CP-201000251
Log # TXNB-10013

SUBJECT: COMANCHE PEAK NUCLEAR POWER PLANT, UNITS 3 AND 4
DOCKET NUMBERS 52-034 AND 52-035
RESPONSE TO REQUEST FOR ADDITIONAL INFORMATION REGARDING THE
ENVIRONMENTAL REVIEW AND SUPPLEMENTAL INFORMATION FOR
PREVIOUS ENVIRONMENTAL QUESTIONS

REFERENCE: Letter, M. Willingham to D. Woodlan, "Request for Additional Information Regarding the Environmental Review of the Combined License Application for Comanche Peak Nuclear Power Plant, Units 3 and 4," dated January 15, 2010 (ML093280707)

MAKEUP WATER INTAKE STRUCTURE
 GENERAL PLAN

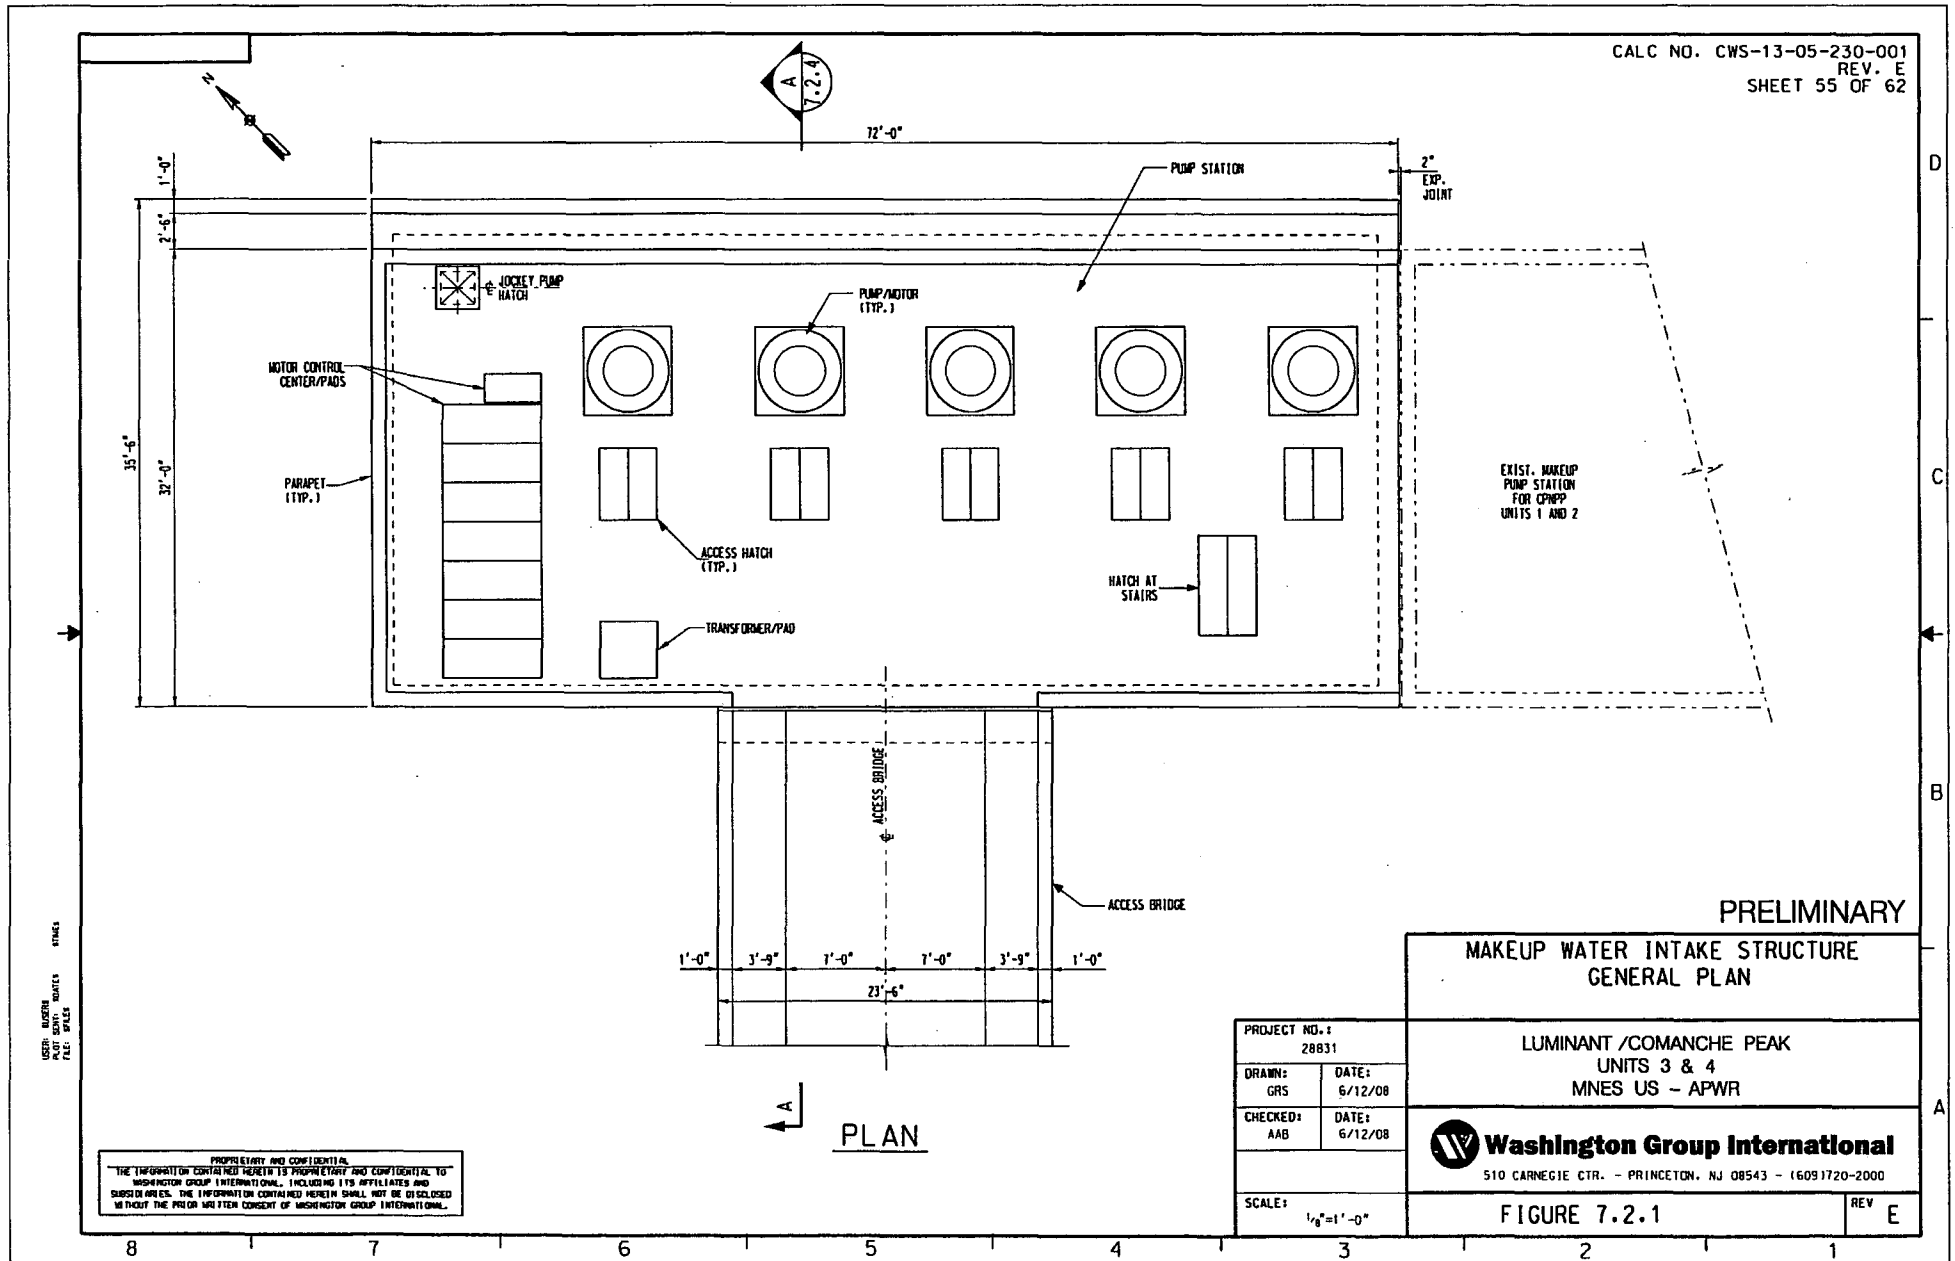
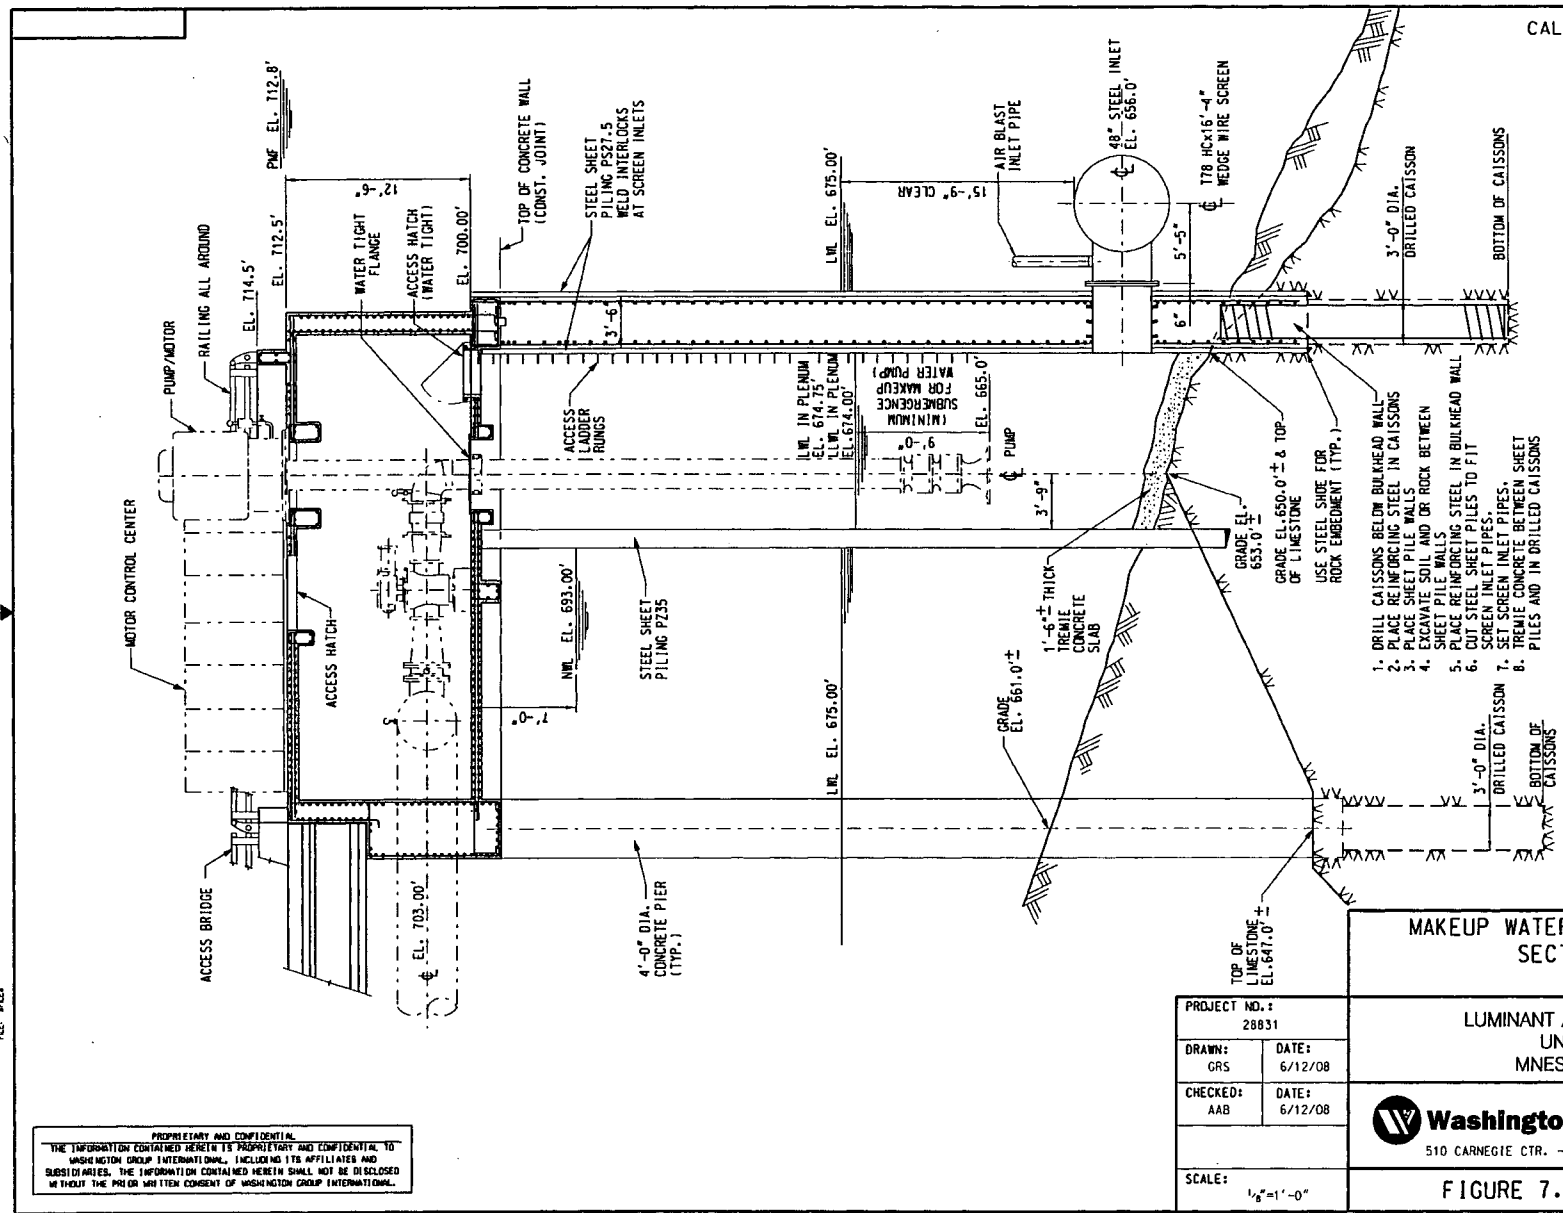
Provide a figure that shows the exterior dimensions of the intake structure with reference to the existing intake and other man-made structures in the immediate vicinity, and displays both the areas that would be disturbed during construction and areas permanently committed to the intake.

Based on the current preliminary design of the Makeup Water Intake Structure and return piping, it is expected that construction of the intake structure and return will take 12 to 18 months. It is not expected to require the installation of cofferdams. Dredging is also not expected other than the collateral movement of loose surface material as a result of drilling. Drilling into the rock is required to install the caissons and sheet piling that make up the foundation and boundary of the intake structure. No material is expected to be removed. This minimal disturbance will occur around the immediate periphery of the intake structure, estimated to be 80 feet long and 40 feet wide, nominally, or approximately 3,200 ft². The Units 3 and 4 Intake structure is adjacent (to the west) of the Units 1 and 2 Intake Structure. The Wolf Hollow intake is located about 200 feet further downstream from the Units 1 and 2 intake. The nearest boat docks are several hundred feet away from this site.

Blowdown Treatment Facility Equipment Layout, BDT-11-13-400-002 Rev. B

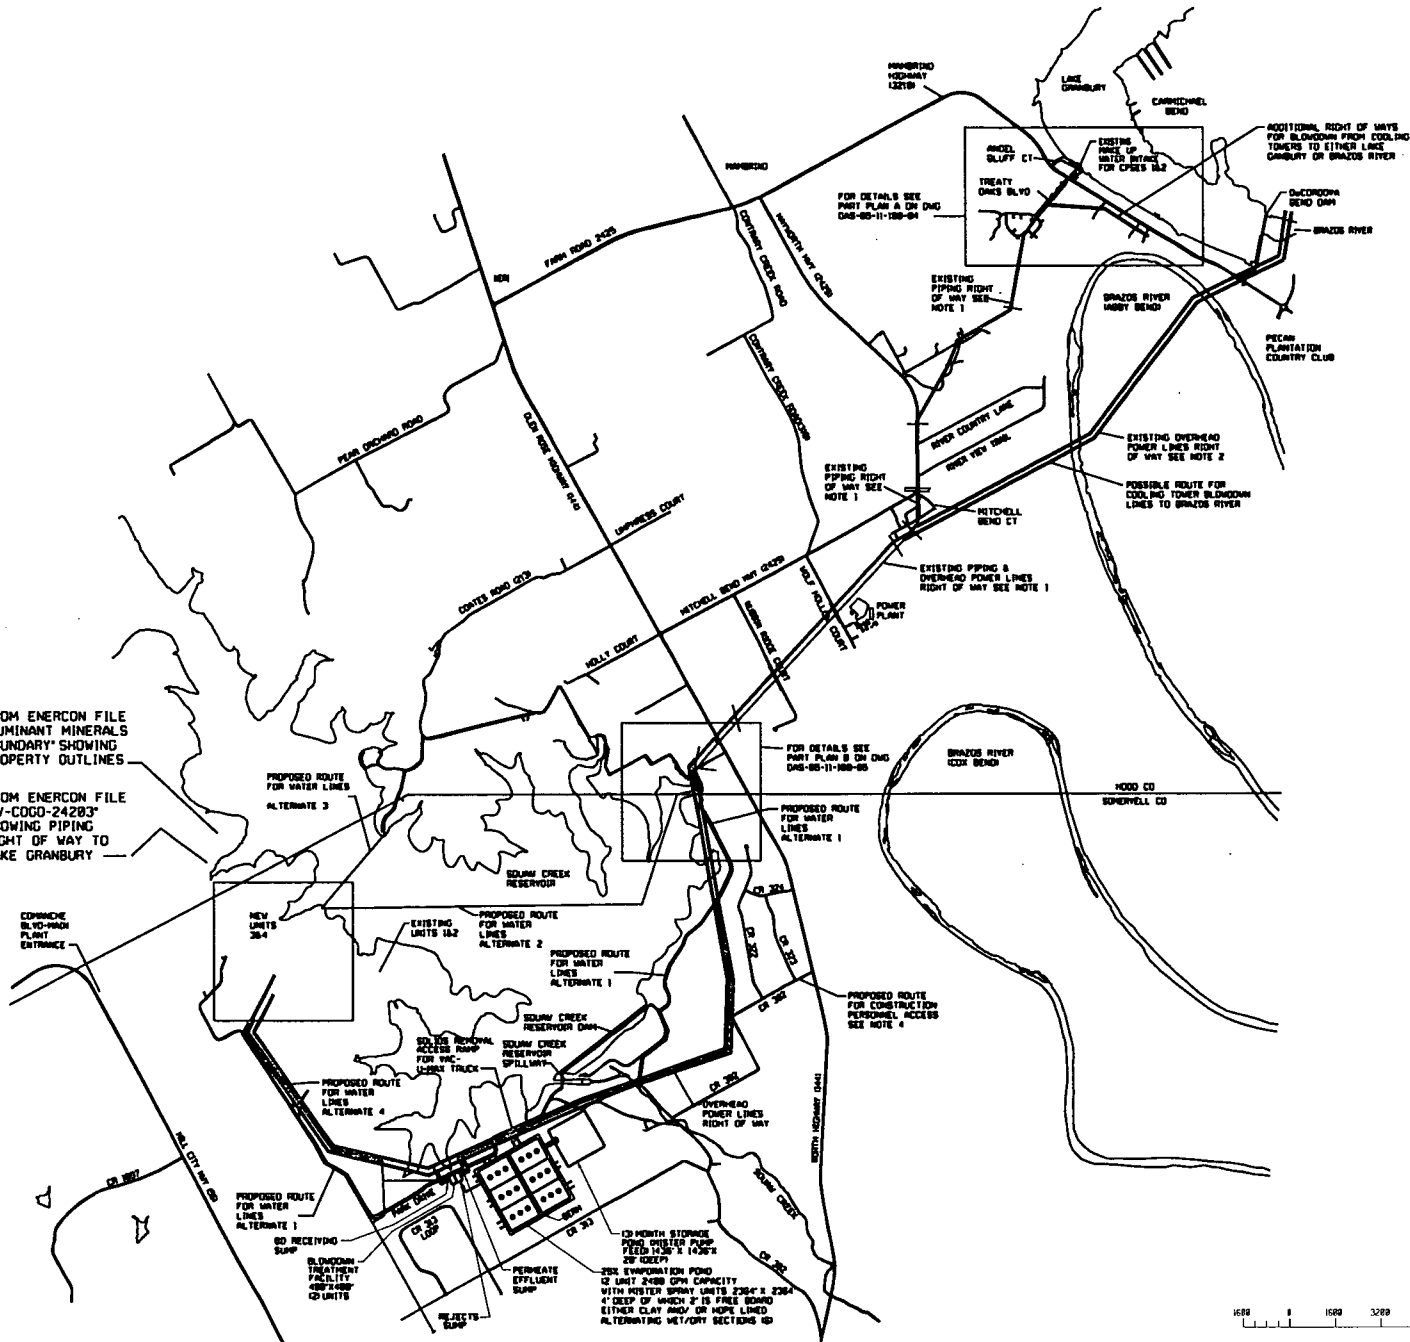
- The Document, "Construction Environmental Controls Plan", as cited in Section 3.9.1.1 of the ER
- Area Plan BDTF GAS-05-11-100-007 Rev. A
- Blowdown Treatment Process Diagram BDT-21-11-130-001 Rev. A
- Blowdown Treatment Facility Equipment Layout BDT-11-13-400-002 Rev. A

ER Subsection 3.9.1.1 simply outlines the different features of the document, "Construction Environmental Controls Plan." The document will be drafted according to the features cited in the ER and will be available at a later date. All other requested documents are attached.

Figure 1
Wheeler Branch Reservoir and Squaw Creek Reservoir
Simplified Construction Water Use Diagram

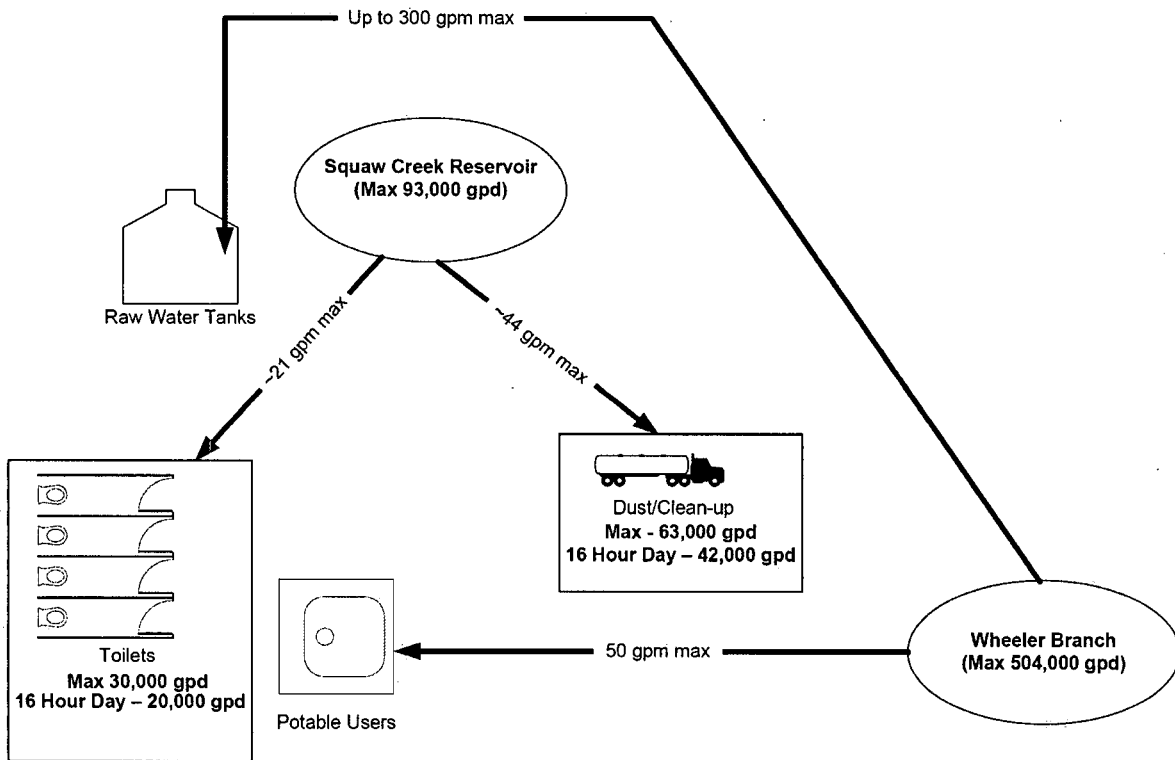
- Provide clarification on the quantity of water that would be used from WBR based on the Somervell County Water Supply Project phases noted in the June 2006 amendment to the Brazos River Region G Water Plan.

Environmental Report Subsections 4.2.1.3 and 4.4.2.3 have been updated to reflect the availability of water from Wheeler Branch. Figure 1 (attached) provides a simplified water use diagram for the construction period.
